Safety Evaluation Report for the Dewey-Burdock Project Fall River and Custer Counties, South Dakota

Materials License No. SUA-1600

Docket No. 40-9075
Powertech (USA) Inc.

March 2013

Figure 2.3-1: Dewey-Burdock Project Regional Geologic Map

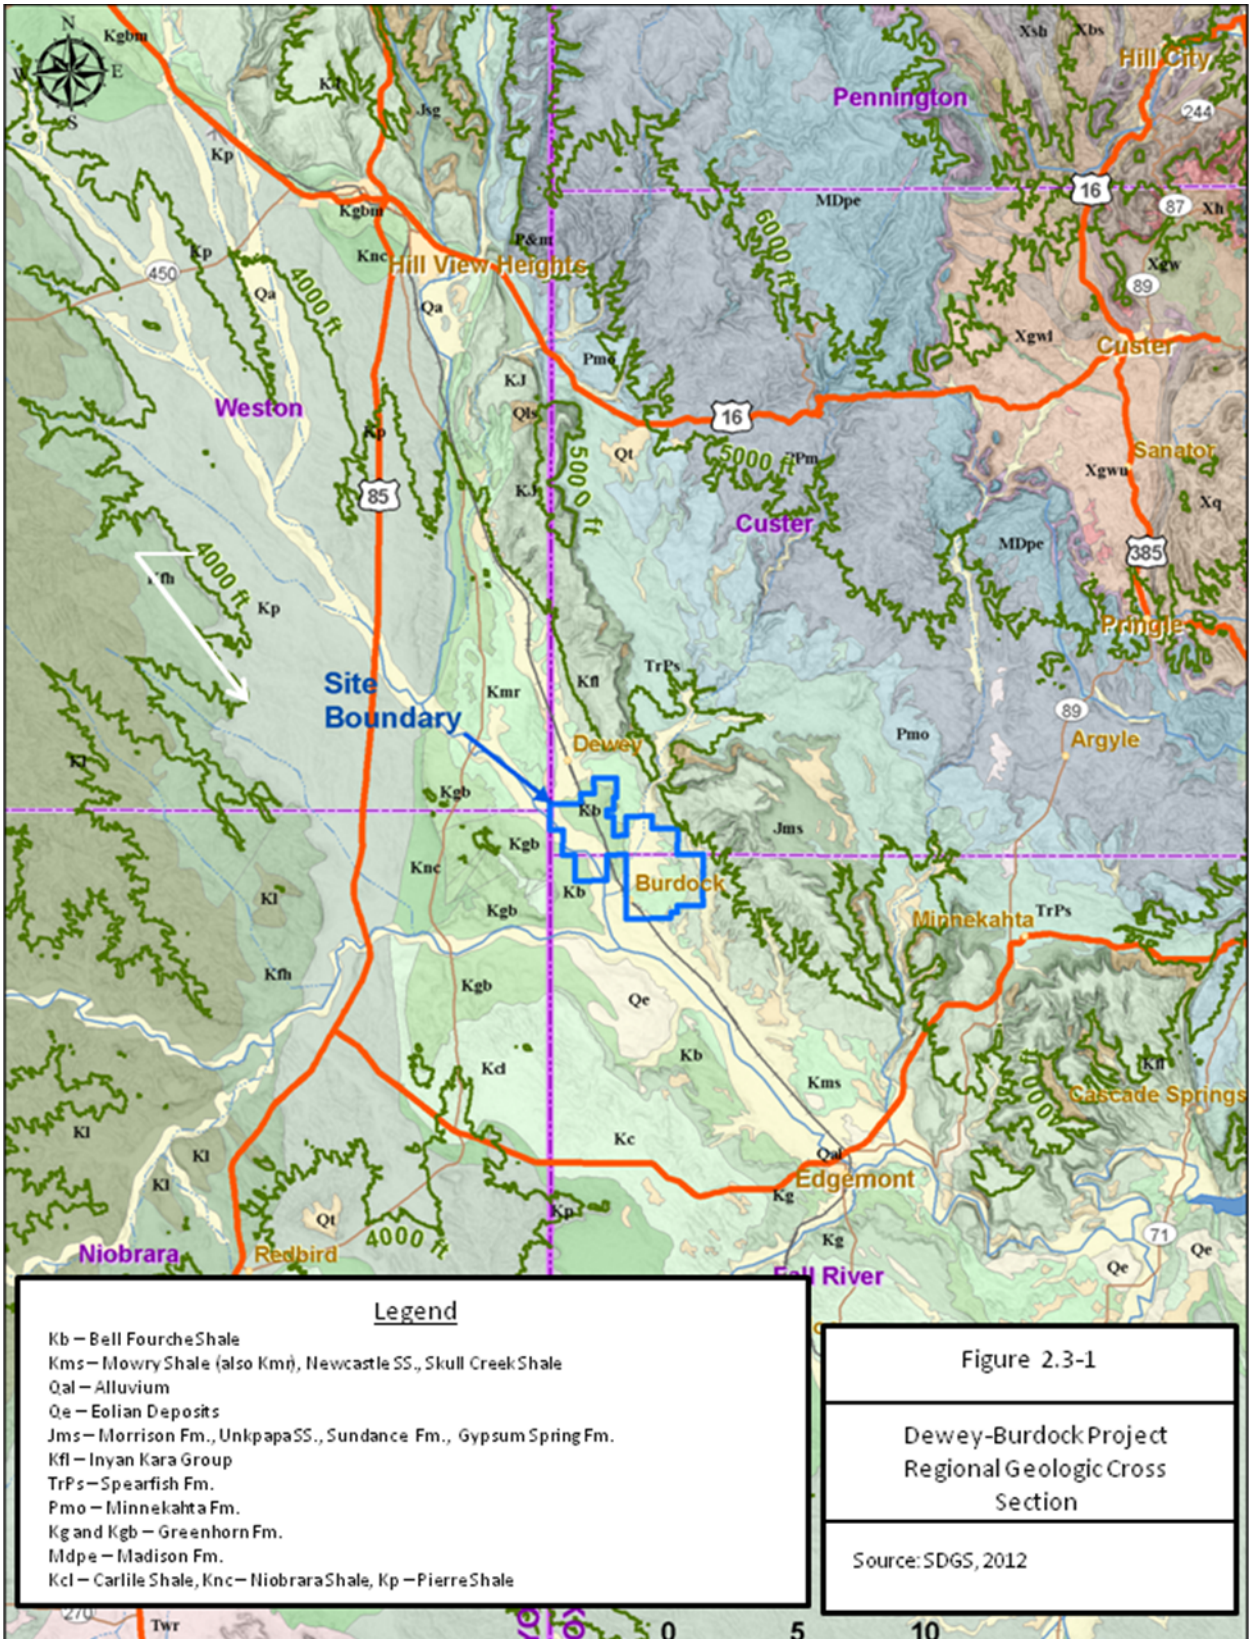
The applicant presents information on regional geology in application Section 2.6 (Powertech, 2009c). Application Figure 2.6-1, representing the regional geology, is an outdated map; therefore, the staff referred to more recent geologic information to describe some aspects of the regional geology. The proposed license area lies within the unglaciated Missouri Plateau Section of the Great Plains Physiographic province (USGS, 2011a). The Dewey-Burdock Project is located on the southwestern flank of the Black Hills uplift that formed the Black Hills during the Laramide Orogeny 60 to 65 million years ago (Timothy T. Bartos, L. L. H., and Kathy Muller Ogle, 2002). The staff also consulted the latest South Dakota geologic map produced by the South Dakota Geologic Survey (SDGS), which is reproduced as SER Figure 2.3-1

(James E. Martin, J. F. S., Mark D. Fahrenbach, Dennis Tomhave, and Layne D. Schulz, 2004). SER Figure 2.3-1 presents the surficial geology of the Black Hills area. The applicant also provided a stratigraphic column of the Black Hills area in application Figure 2.2-3 (Powertech, 2009c).

Figure 2.3-3: Dewey-Burdock Project Site Geologic Map

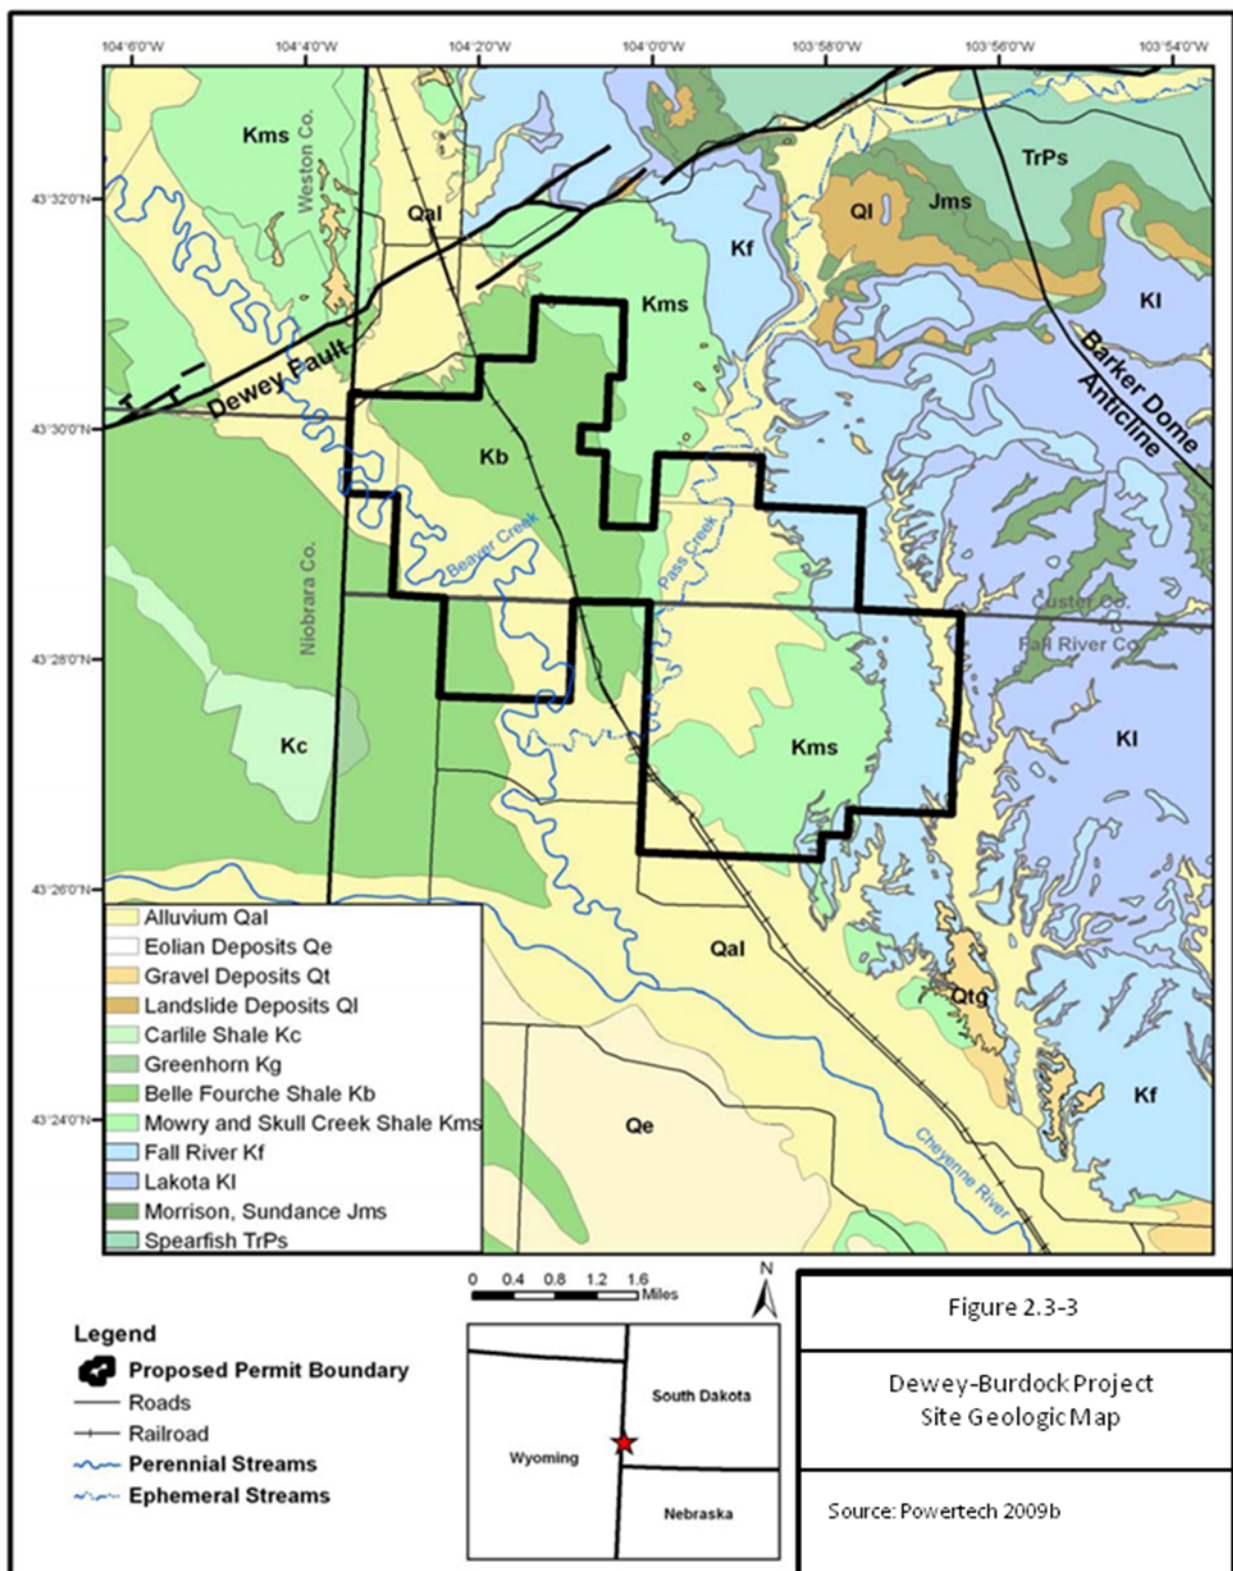
The applicant provided a description of the site geology based on site data and outside information. Application Figure 2.6-2 presents the Dewey-Burdock Project surficial geology, which is reproduced as SER Figure 2.3-3 (Powertech, 2009c). The applicant states that the Fall

Figure 1. Comparison of the Reported Drawdown and Drawdown from the modeling Software

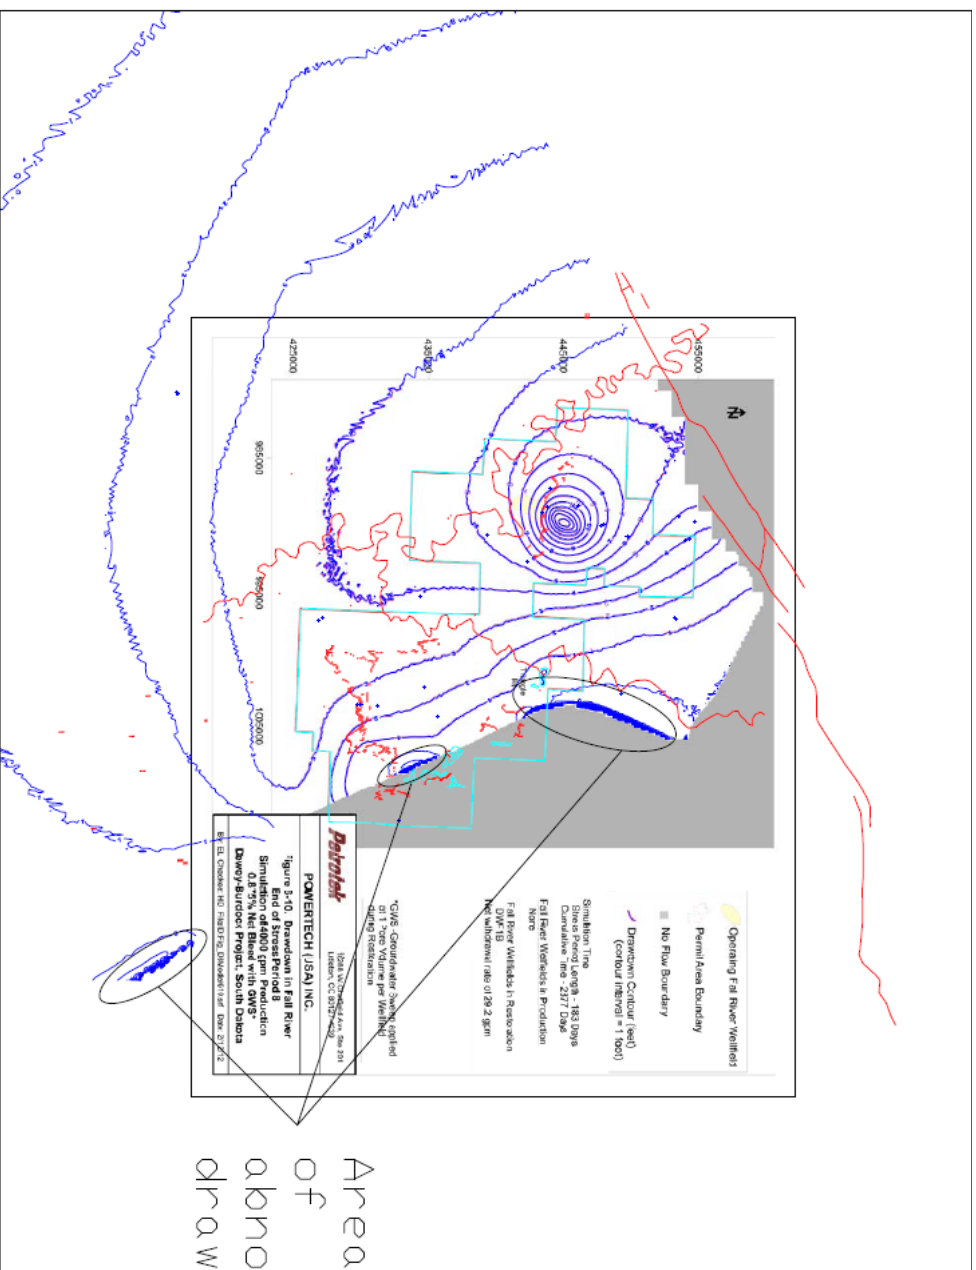
Staff reviewed the model geometry, hydraulic properties and parameters and locations of the boundaries. Several minor discrepancies were noted between the electronic files and the report (Table 1). In general, the discrepancies represent minor errors and are common for complex models. Most of the discrepancies would not appreciably impact the model predictions; however, staff was concerned about the abnormal drawdown adjacent to the GHB conditions (Figure 1). The abnormal drawdown may be attributed to discrepancies noted in the recharge, storativity or GHBs (see Table 1), or, conflicts with the starting head file.¹

Staff corrected the model for discrepancies in recharge, storativity and GHBs, and established starting heads for the predictive simulation using the output from the steady-state calibration simulation. Correcting the model affected the predicted drawdowns in the Fall River Formation and Chilson Member, as shown in Figure 2 and Figure 3, respectively. The effect of the corrected model on the Fall River Formation model-predicted drawdown is to increase the drawdown by approximately 1 foot. The effect on the Chilson Member model-predicted drawdown is less than that for the Fall River Formation.
